Access Compliance Report

Public Rights-of-Way

Intersection ID: N/A	Main Street: SENECA_PL	Cross Street: N/A	Location: NE
ADA ID: 0A7D4589F95C	Ramp Type: BlendTrans2	Initial Pass/Fail: Fail	Overall Compliance: No
			Severity Score: 21.25

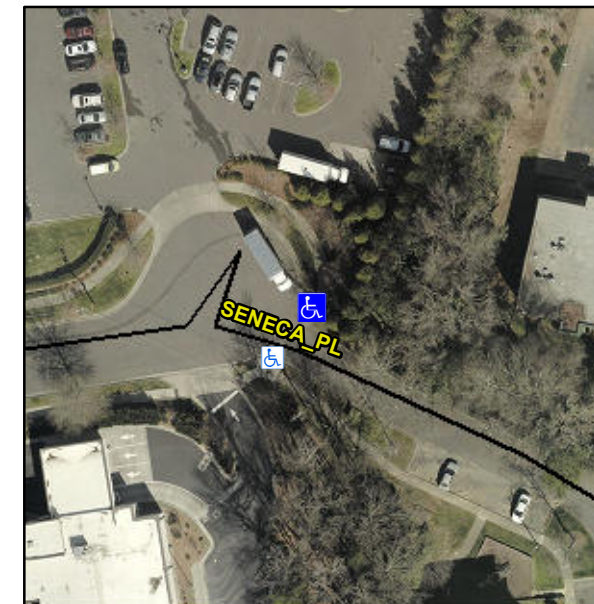
Not Found, R304.5.1, R304.5.3

Compliance	Description	Data	Compliance	Description	Data
N/A	Ramp Length (in)	110.0	Yes	BlendTrans Slope (%)	2.9
No	Ramp Width (in)	46.0	No	BlendTrans XSlope (%)	6.3
N/A	Flare Type LT	N/A	N/A	Flare Type RT	N/A
N/A	Flare Slope LT (%)	N/A	N/A	Flare Slope RT (%)	N/A
N/A	Flare Traversable LT?	N/A	N/A	Flare Traversable RT?	N/A
N/A	Landing Length (in)	N/A	N/A	DWS Provided?	N/A
N/A	Landing Width (in)	N/A	N/A	DWS Contrast?	N/A
N/A	Landing Slope (%)	N/A	N/A	DWS Length (in)	N/A
N/A	Landing X Slope (%)	N/A	N/A	DWS Full Width?	N/A
N/A	Landing Curb? (Y/N)	N/A	N/A	DWS Offset (in)	N/A
N/A	Shared Landing?	N/A			
N/A	Gutter Ponding?	N/A	N/A	Gutter Slope (%)	N/A
N/A	Gutter Lip Ht (in)	N/A	N/A	Gutter X Slope (%)	N/A
N/A	Painted X Walk1?	No	N/A	Painted X Walk2?	N/A
	X Walk 1 Direction	To SW		X Walk 2 Direction	N/A
	X Walk 1 Width (in)	N/A		X Walk 2 Width (in)	N/A
	X Walk 1 Slope (%)	0.4		X Walk 2 Slope (%)	N/A
	X Walk 1 X Slope (%)	4.2		X Walk 2 X Slope (%)	N/A

Remove & Replace Curb Ramp With Two New Directional Ramps or Equivalent.
